**Addendum #2
to OPTIMOD-AM® Operating Manual**

Third edition, P/N 95032-000-03

This addendum updates the 9100A Operating Manual so it can be temporarily used as an operating manual for the new Model 9100B OPTIMOD-AM, while the 9100B Operating Manual is being checked for accuracy and printed. You will be sent a copy of the finished 9100B Operating Manual only if you return the Registration Card or otherwise notify us of the unit's whereabouts.

The 9100B differs from the 9100A in that the pre-emphasis and 10kHz low-pass filtering recommended by the NRSC have been incorporated in the 9100B, and the 5kHz low-pass filter required by European broadcasters is standard on the 9100B. In effecting these changes, the optional Card #1-F (mono) or #1-S (stereo) for the 9100A has been replaced by the standard Card #1F10 (mono) or #1S10 (stereo) in the 9100B.

Fig. 1: Jumper Positions, ACC-023 NRSC Monitor Rolloff Filter (1 ch.)

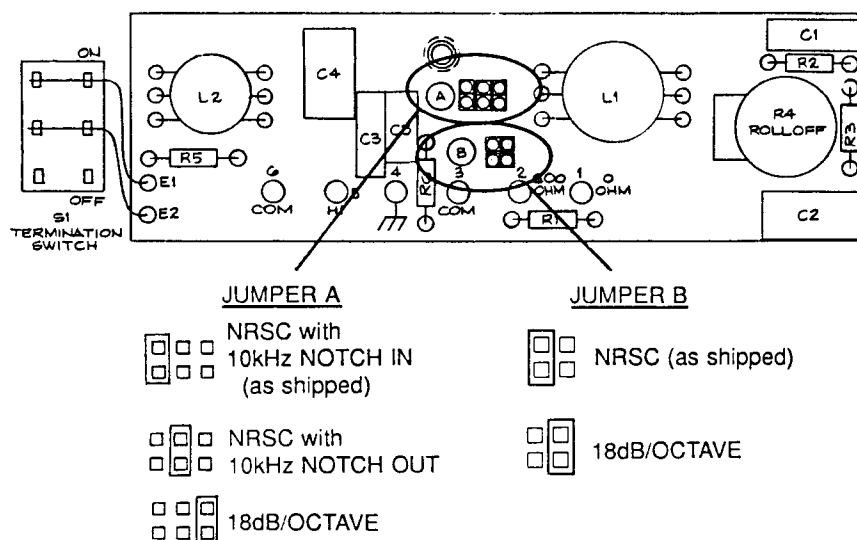
Jumpers A and B select either the NRSC-standard de-emphasis or the adjustable de-emphasis on an 18dB/octave curve. See Fig. 1 for jumper positions. The jumpers are located on the circuit board inside the Monitor Rolloff Filter chassis. NRSC de-emphasis can be selected with or without a 10kHz notch filter. The notch filter will reduce any audible artifacts that might result from ringing introduced by the very sharp 10kHz low-pass filter specified by the NRSC, and will eliminate 10kHz carrier beats in off-air monitoring. This notch filter is disabled if the 18dB/octave rolloff is selected.

Fig. 2: NRSC-standard Rolloff Curve
ACC-023 Monitor Rolloff Filter

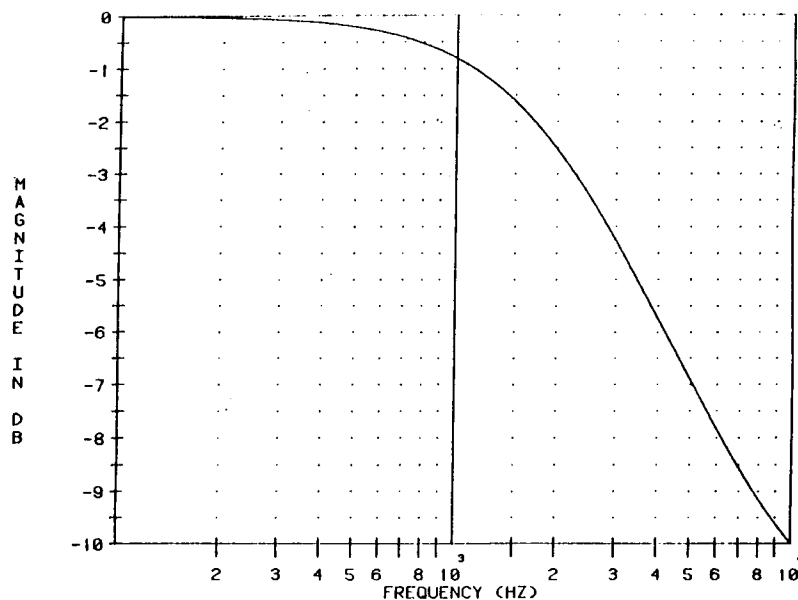
If you have set the jumpers for the adjustable 18dB/octave rolloff, adjust the Monitor Rolloff Filters' ROLLOFF controls for the most pleasing sound from your monitor. This control is disabled when the jumpers are positioned to select NRSC-standard de-emphasis. See Fig. 2 for the NRSC rolloff curve (Fig. 2-1 in the 9100A Operating Manual shows the 18dB/octave rolloff curves). For additional information about using this Monitor Rolloff Filter with the alternate (non-NRSC) pre-emphasis modules supplied with OPTIMOD-AM, see Addendum #1.

Fig. 3: Jumper Positions, Cards #1F10 and #1S10

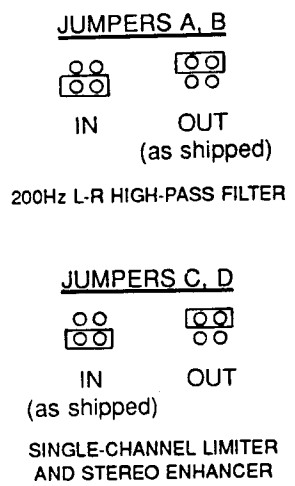
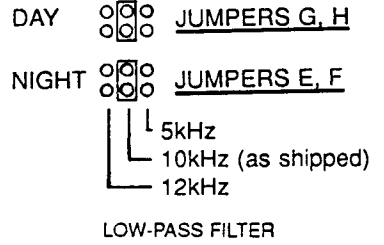
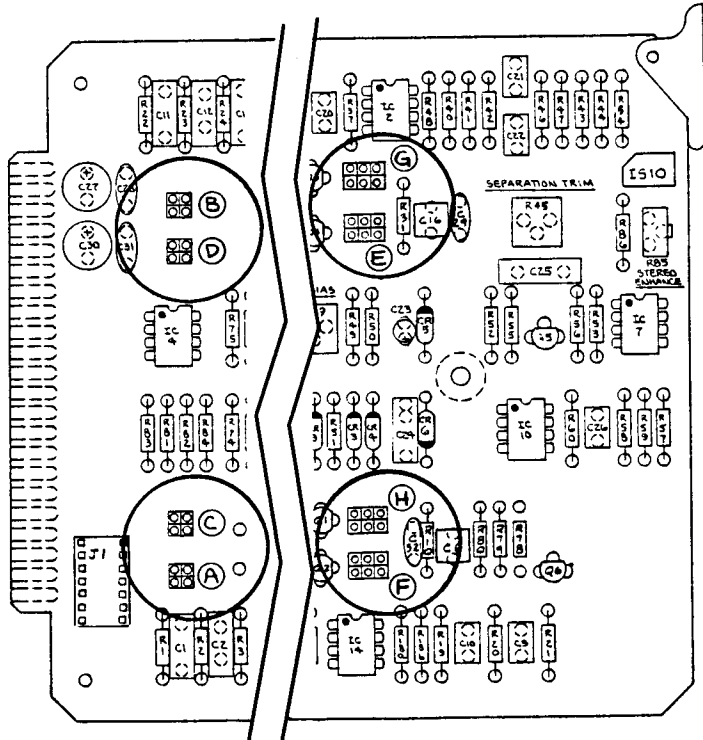
- 3) **Low-pass filtering** is selected by jumpers on the 9100B/1's Card #1F10 or on the 9100B/2's Card #1S10. Day and night 10kHz low-pass filtering is specified by the NRSC standard. 5kHz and 12kHz low-pass filtering are also available. Any of these three low-pass filtering options may be chosen for day operation, and the same or either of the other two may be chosen for night operation. See Fig. 3 for jumper positions. See Appendix C for access to circuit cards.

References to the single-channel limiter and stereo enhancer in the 9100A Operating Manual still apply, except that the limiter and enhancer are now located on Card #1S10. See Fig. 3 for jumper positions.

References to the 200Hz L-R high-pass filter in the 9100A Operating Manual still apply. See Fig. 3 for jumper positions.

On Card #1F10, jumpers A (night) and B (day) select 5kHz, 10kHz, or 12kHz low-pass filtering in any combination for day and night filtering. On Card #1S10, jumper pairs E & F (night) and G & H (day) select the low-pass filtering. The NRSC standard specifies 10kHz low-pass filtering for both day and night. Card #1S10 jumpers C and D select or defeat the single-channel limiter and stereo enhancer. Card #1S10 jumpers A and B select or defeat the 200Hz L-R high-pass filter. Jumper positions are shown in Fig. 3 and on each card's assembly drawing.

TITLE:
ASSEMBLY DRAWING
IS10 CARD
31013-000-01

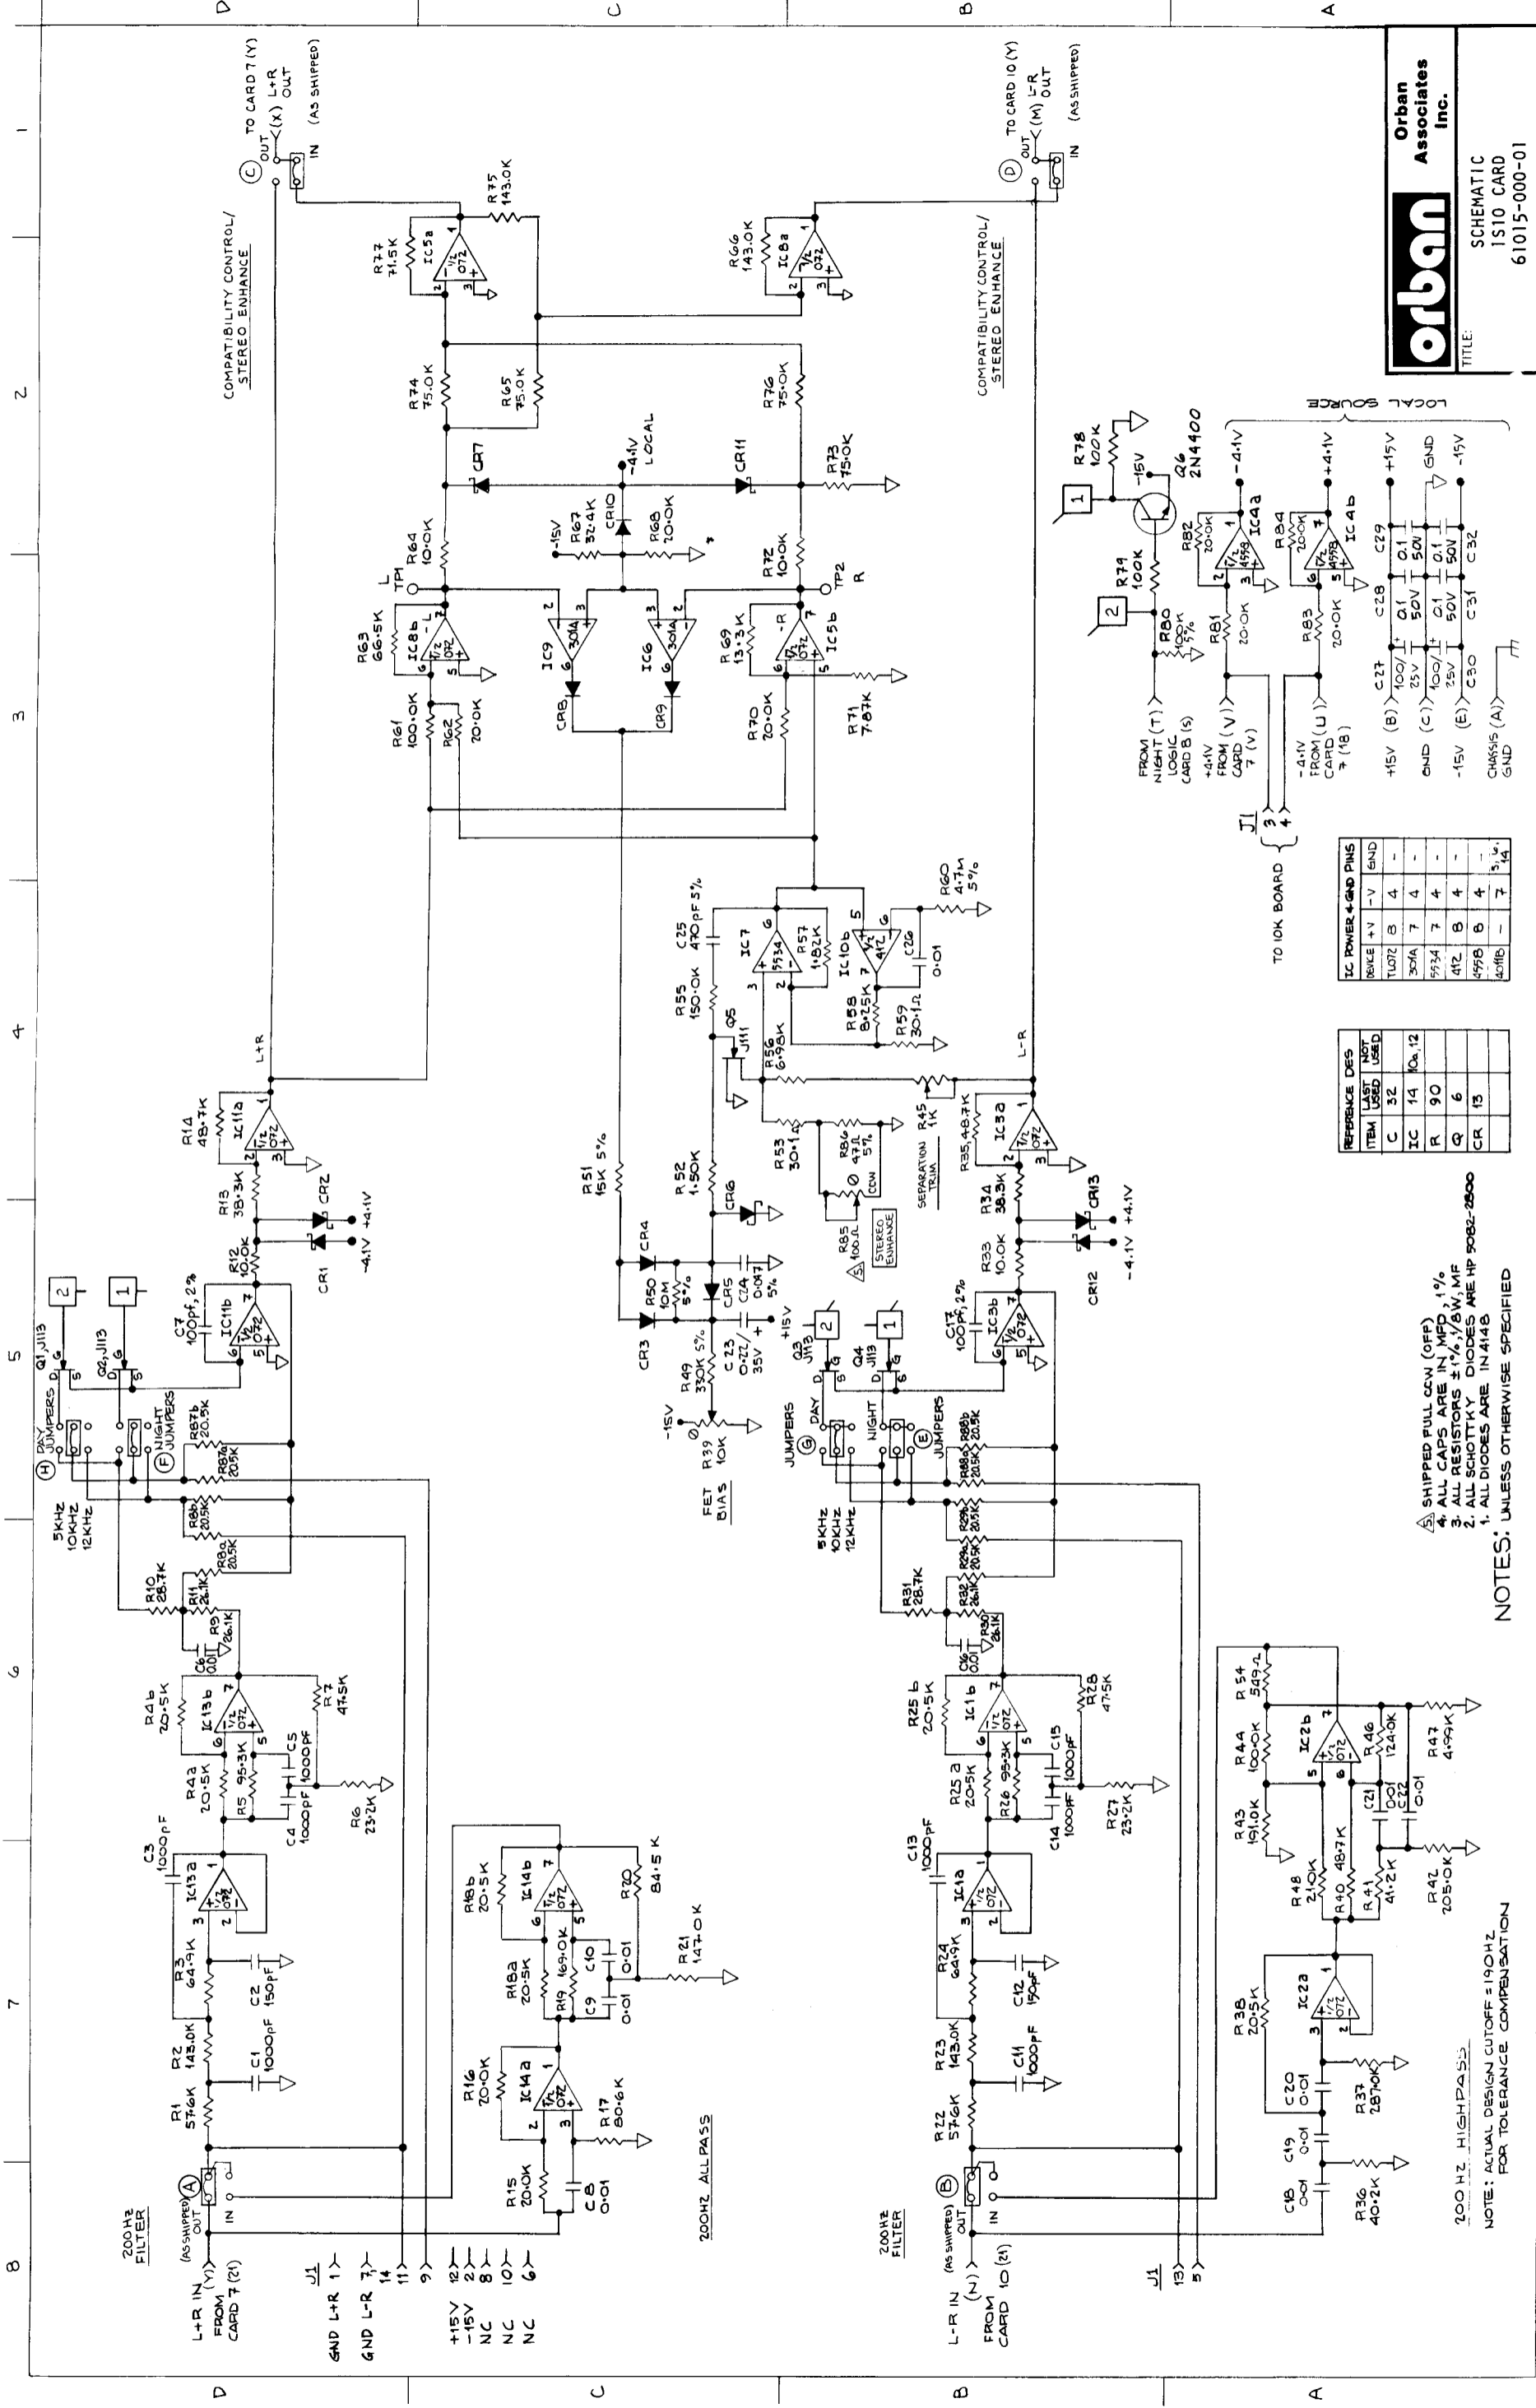
If you wish to use the stereo enhancer with Kahn or Magnavox exciters, defeat the single-channel limiter by de-soldering one side of diodes CR7 and CR11 from Card #1S10 (see assembly drawing in this addendum for locations of components).
